Access Compliance Report

Public Rights-of-Way

Intersection ID: 10023017	Main Street: CENTER_PARK_DR	Cross Street: N/A	Location: NW
ADA ID: 5A016117BA08	Ramp Type: BlendTrans1	Initial Pass/Fail: Fail	Overall Compliance: No
			Severity Score: 33.75

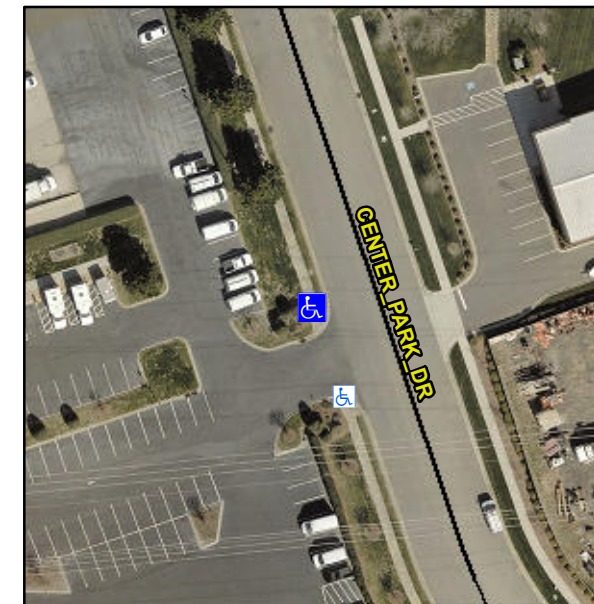
Not Found, R304.5.1, R304.5.3

Compliance	Description	Data	Compliance	Description	Data
N/A	Ramp Length (in)	76.0	Yes	BlendTrans Slope (%)	2.3
No	Ramp Width (in)	46.0	No	BlendTrans XSlope (%)	9.5
N/A	Flare Type LT	N/A	N/A	Flare Type RT	N/A
N/A	Flare Slope LT (%)	N/A	N/A	Flare Slope RT (%)	N/A
N/A	Flare Traversable LT?	N/A	N/A	Flare Traversable RT?	N/A
N/A	Landing Length (in)	N/A	N/A	DWS Provided?	N/A
N/A	Landing Width (in)	N/A	N/A	DWS Contrast?	N/A
N/A	Landing Slope (%)	N/A	N/A	DWS Length (in)	N/A
N/A	Landing X Slope (%)	N/A	N/A	DWS Full Width?	N/A
N/A	Landing Curb? (Y/N)	N/A	N/A	DWS Offset (in)	N/A
N/A	Shared Landing?	N/A			
N/A	Gutter Ponding?	N/A	N/A	Gutter Slope (%)	N/A
N/A	Gutter Lip Ht (in)	N/A	N/A	Gutter X Slope (%)	N/A
N/A	Painted X Walk1?	No	N/A	Painted X Walk2?	No
	X Walk 1 Direction	To S		X Walk 2 Direction	To E
	X Walk 1 Width (in)	N/A		X Walk 2 Width (in)	N/A
	X Walk 1 Slope (%)	2.6		X Walk 2 Slope (%)	8.5
	X Walk 1 X Slope (%)	7.0		X Walk 2 X Slope (%)	4.4

N/A	Ramp inside XWalk1?	N/A	N/A	Ramp inside XWalk2?	N/A
	Road Slope (%)	3.9		Clear Space?	N/A
	Road X Slope (%)	0.7	N/A	Clear Space to XWalk (in)	N/A
N/A	Any Obstructions?	N/A	N/A	Storm Grate/Utility Hazard?	N/A
	Obstruction Type			Storm Grate/Utility Type	
		N/A			N/A
			Yes	Surface Condition? (G/P)	Good
			No	Curb Slope (%)	13.3

Remove & Replace Curb Ramp With Two New Directional Ramps or Equivalent.
